EARLY DESIGN GUIDANCE #2
MLK TOWNHOUSES
3817 MLK JR WAY S
3029291

HYBRID

Additional Study : Larger Amenity Spaces with More Usable Areas

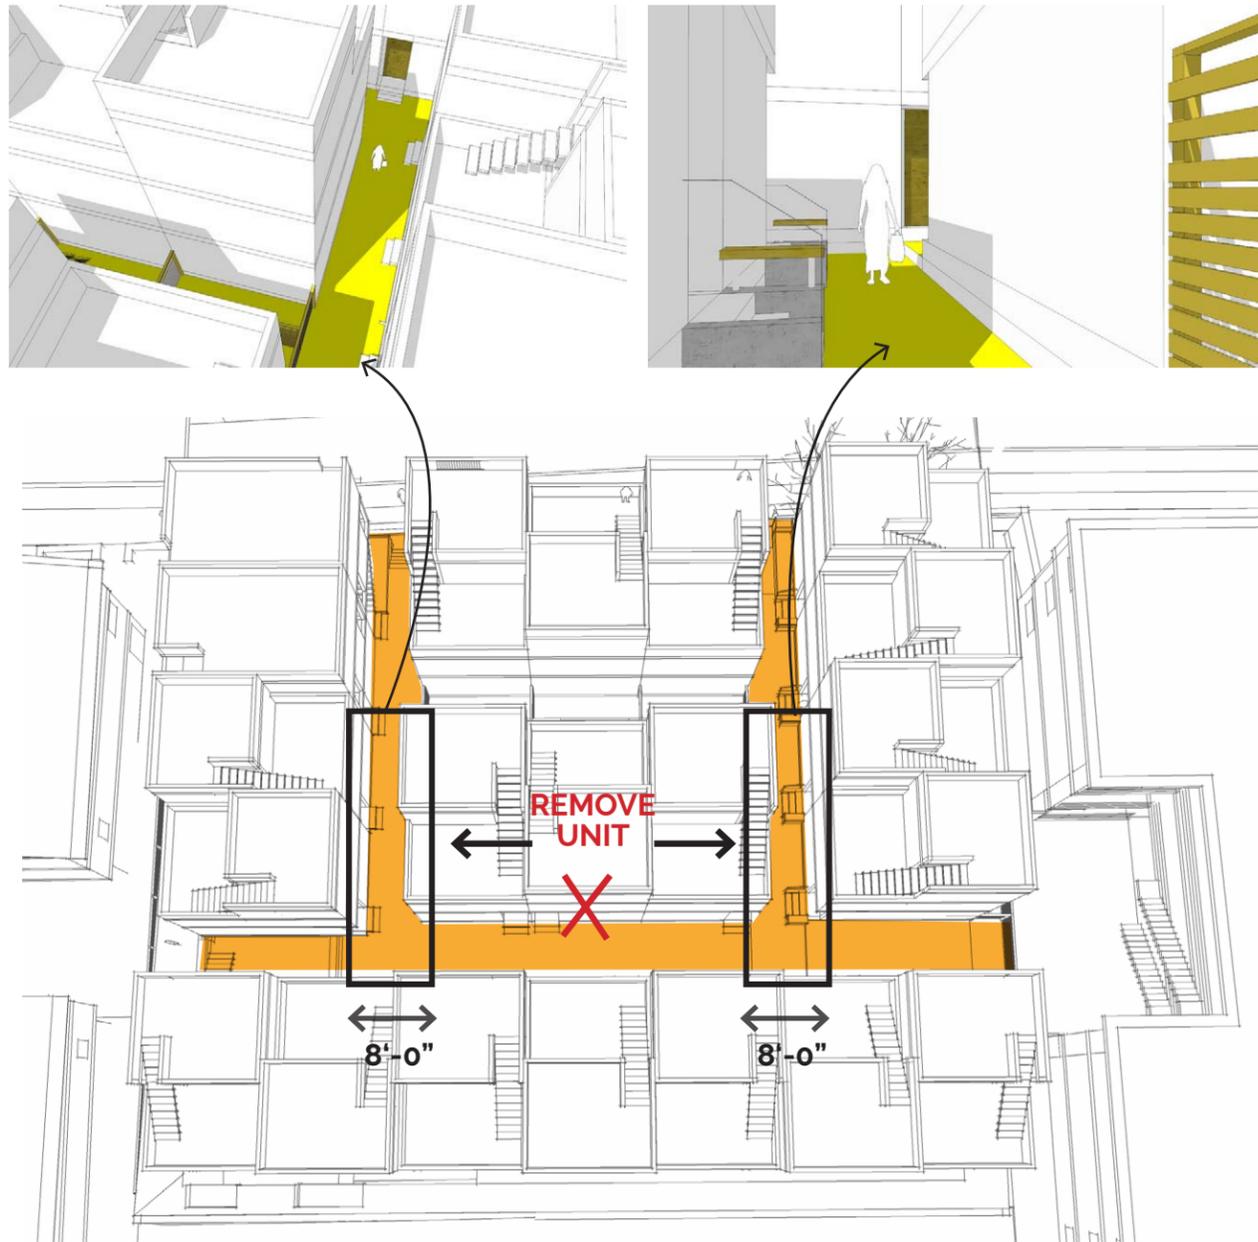
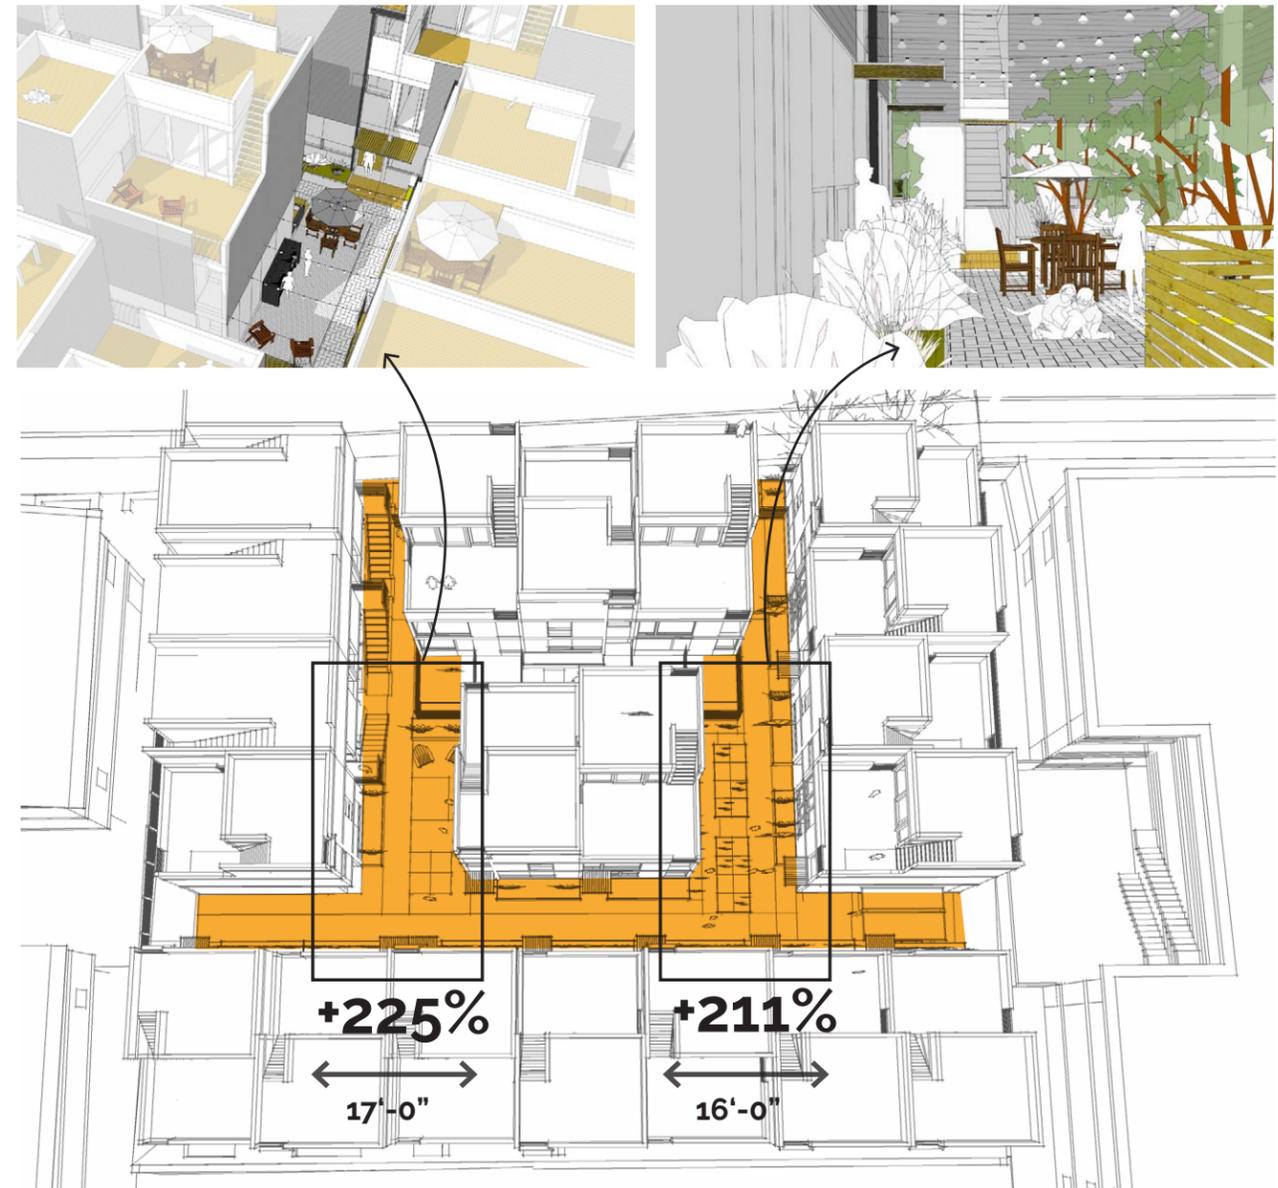
EDG Comment: 1. Massing and Site Configuration:

However, there was concern with the proposed layout and the Board indicated support for the site configuration shown in Option 2, which allowed for a larger central courtyard. The Board recommended the applicant develop an alternative that combines elements of both Option 2 and Option 3 and return for a second EDG meeting to address the site planning issues. (CS2-D-1. Existing Development and Zoning) / a. The Board was concerned with unit privacy and access to light and air for the proposed greenspace/amenity areas shown on Option 3. The Board recommended the site be reconfigured to allow for larger, more usable amenity areas and to provide more separation between the primary entries to allow for secure transitional spaces. (CS1-B-2. Daylight and Shading, DC1-A-2. Gathering Places).

4. Landscaping/Amenity Areas:

a. The Board was concerned with the proposed dimensions for the pedestrian pathways, landscaping, and amenity areas proposed in Option 3 and supported the larger central courtyard shown in Option 2. The Board suggested that these areas be reconfigured to provide opportunity for interaction and increase usability.

The revised courtyard shown here takes the wider and more functional spaces shown in Option 2 of the first EDG meeting and incorporated those techniques onto Option 3 resulting in much larger and more functional central spaces that will get much more sunlight and use. The uses in both courtyard have also been developed to include a kids play area as well as a barbecue zone.

EDG #2 - REMOVE CENTER UNIT & CREATE PATIOS-
17' x 36' = 610 sf (N) & 16'x36'=574 sf (S)

By removing an entire unit from the center of the site and widening these two amenity areas from 8' to 16'&17' these spaces are now generous enough to fill with program for the residents to occupy and enjoy.

Additional Study : More Secure Transitional Spaces

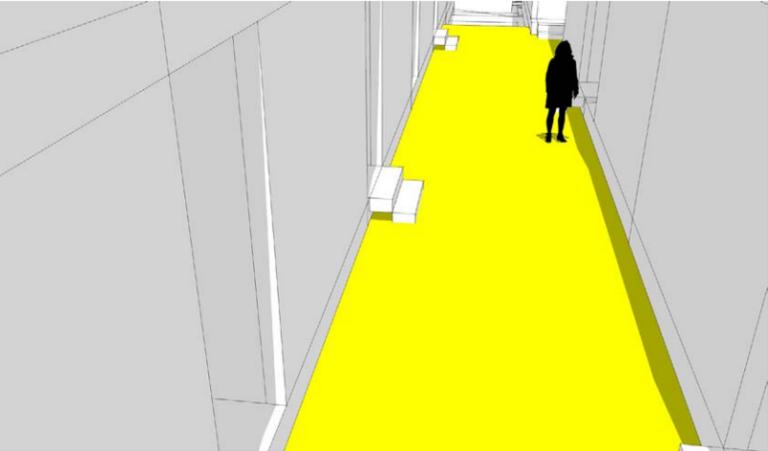
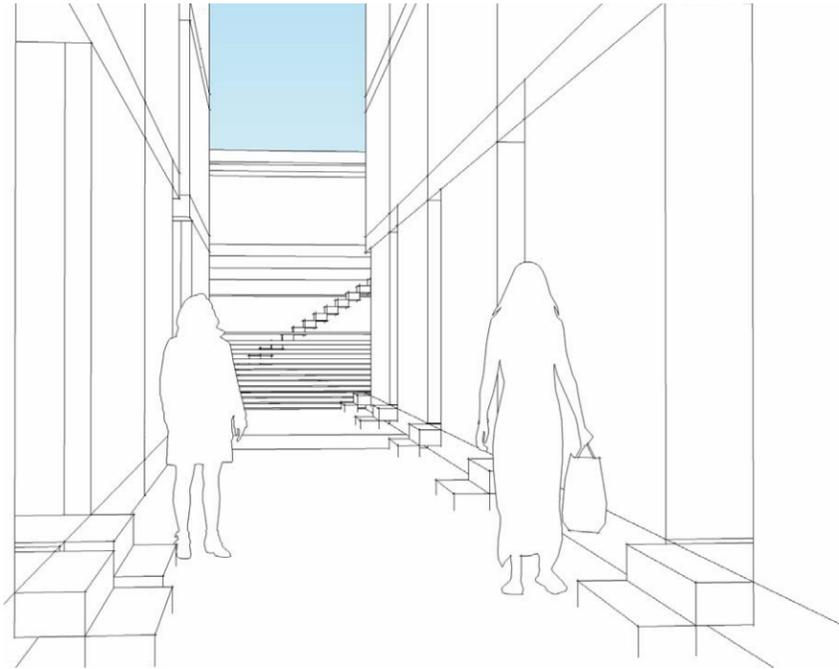
EDG Comment: 1. Massing and Site Configuration:

a. ... and to provide more separation between the primary entries to allow for secure transitional spaces. (CS1-B-2. Daylight and Shading, DC1-A-2. Gathering Places)

A higher degree of privacy and security was obtained within the interior courtyard unit entries by first widening the courtyard 16% from 10' to 11'-7" and by adding raised planters to create a buffer between adjacent units and to assist in providing more privacy to those ground floor uses.

EDG #2 - Widened 16% to 11'-7" with raised planters and stoops

To create more privacy for these interior unit entries the courtyard was widened from 10' to 11'-7" and raised planters and stoops allow for vertical buffers to help mitigate concerns of safety while also allowing for a lush and diverse landscape.

Additional Study: Garage Entry - more visibility and emphasis

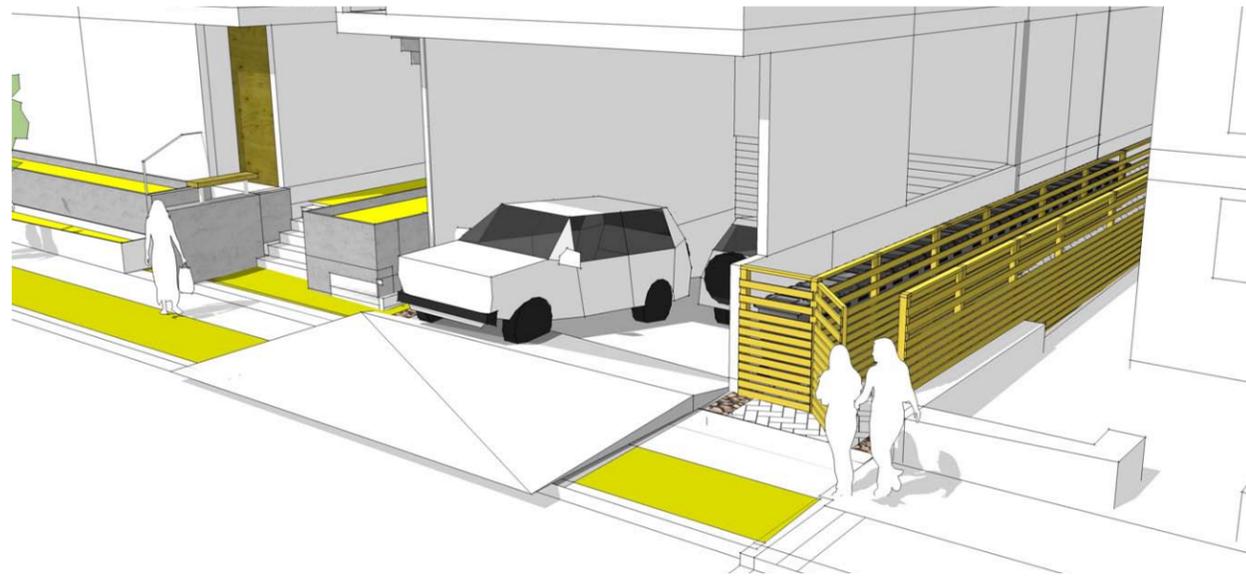
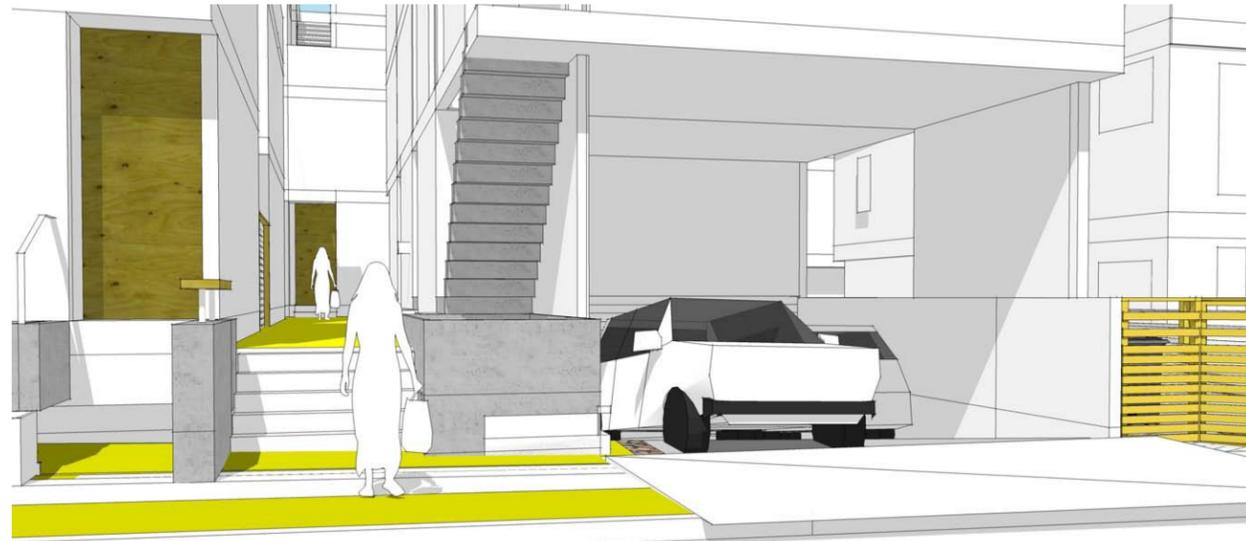
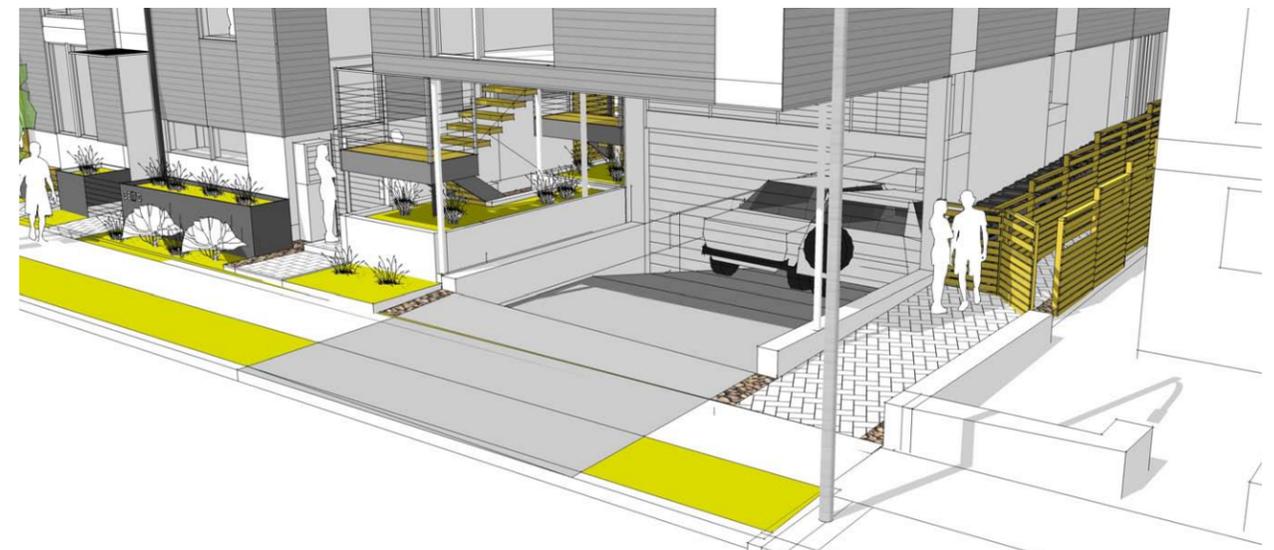
2. Vehicular Access and Pedestrian Circulation:

b. The Board was concerned with the potential conflict between pedestrian activity along the sidewalk and vehicles accessing the garage. The Board recommended developing a design that minimizes the massing at the garage entry to improve vehicular sight lines and pedestrian safety. The Board also recommended delineation of the driveway through a change in the hardscape so the transition area between the sidewalk and driveway is easily identifiable. (DC1-B-1. Access Location and Design, DC4-D-2. Hardscape Materials)

c. The Board instructed the applicant to explore methods to create an enhanced sense of entry to garage and incorporate it into the overall design.

The solid walls present on both sides of the garage limited visibility to pedestrians and the deeply inset door created a cavernous and dangerous space.

The garage entry has been modified with the board's recommendations. By removing mass and recessing fencing the sightlines are dramatically improved from EDG #1. See description below for additional changes.

EDG #2 - Open space with metal columns, closer (screened) garage entry, recessed trash enclosure and a change in paving material from the sidewalk.

All of these changes, in addition to cladding the ceiling in a wood soffit, a similar material to the fencing and other wood elements on the site to integrate the garage entry into the overall design language, lends to a more inviting, safe and attractive garage entry.

3. Primary Entries:

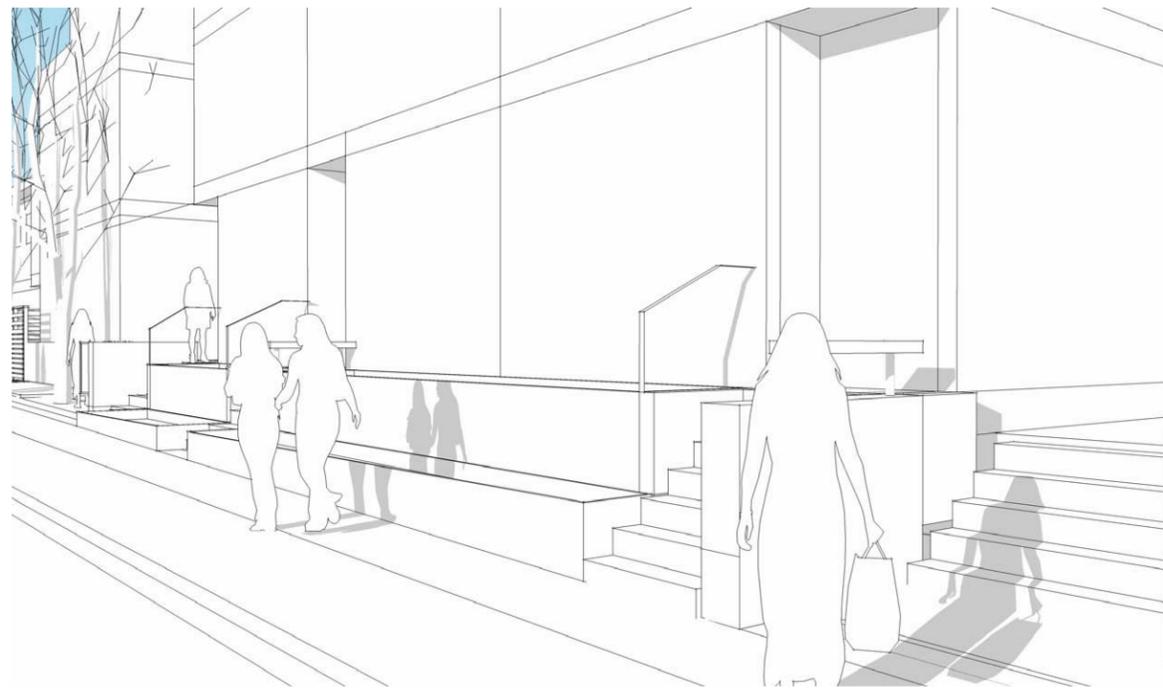
The Board was concerned with privacy issues for the units facing Martin Luther King Jr. Way South as their entries are close to and easily accessible from the sidewalk. The Board recommended the use of transitional spaces and other screening elements in addition to the proposed change in elevation to provide a buffer from public to private.

The entries to the units along MLK have been revised to include secure transitional spaces in the form of stoops that are either perpendicular to the sidewalk to parallel. These units are also buffered from the street by raised planters that not only provide a physical barrier but also screening from the plants.

EDG #2 - Gated Stoops in addition to raised planters to provide secure threshold between the units and the right of way.

Additional Study: Wayfinding and Entries to underground Garage & Trash Enclosure

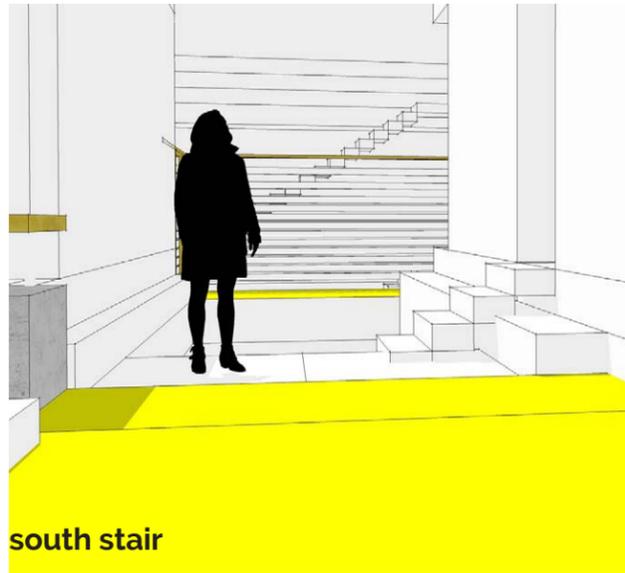
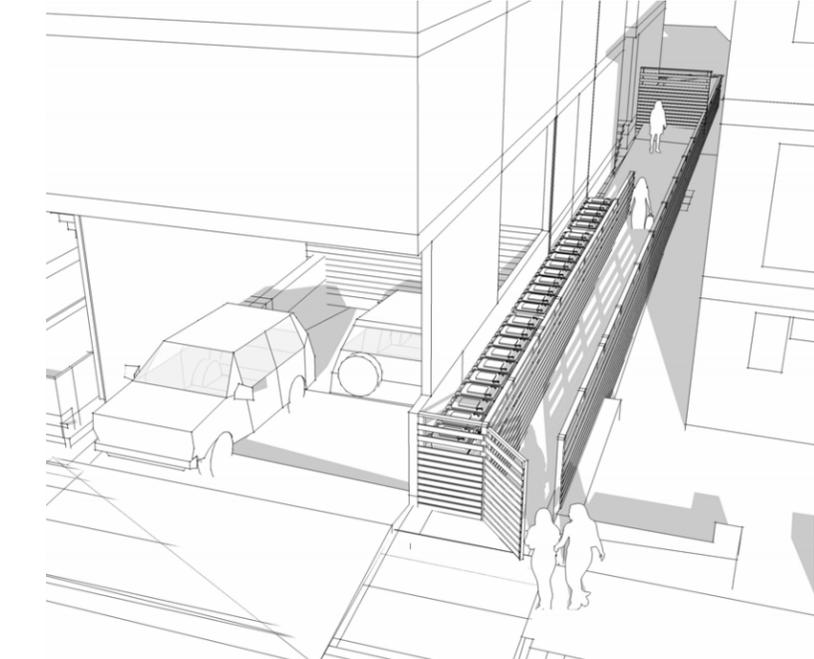
2. Vehicular Access and Pedestrian Circulation:

a. The Board supported locating the parking below grade (proposed in Option 2 and Option 3), and away from pedestrian traffic to minimize potential conflict. The Board also recommended incorporating various wayfinding elements (lighting, signage, etc.) to highlight the stairs to and from the garage. (PL2-D-1. Design as Wayfinding, DC1- B-1. Access Location and Design, DC1-C-1. Below-Grade Parking)

The north and south staircases down to the below grade parking garage have been either covered with a canopy to prevent rain (south stair) or internalized (north stair). The north stair also features signage elements and a change in paving material to call it out to pedestrians.

EDG #2 - Weather protection and wayfinding elements provided

5. Recycling and Waste Location:

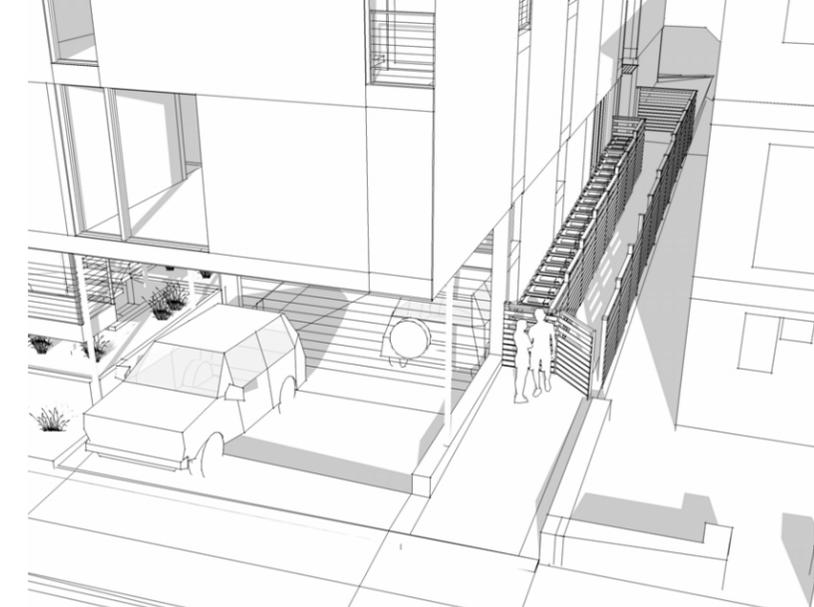
The Board directed the applicant to develop an attractive enclosure that fits into the overall architectural concept and incorporate screening elements to provide a buffer from the street and adjacent property.

EDG#2 - Trash Enclosure recessed from street and constructed out of terraced wood fence to follow slight incline.
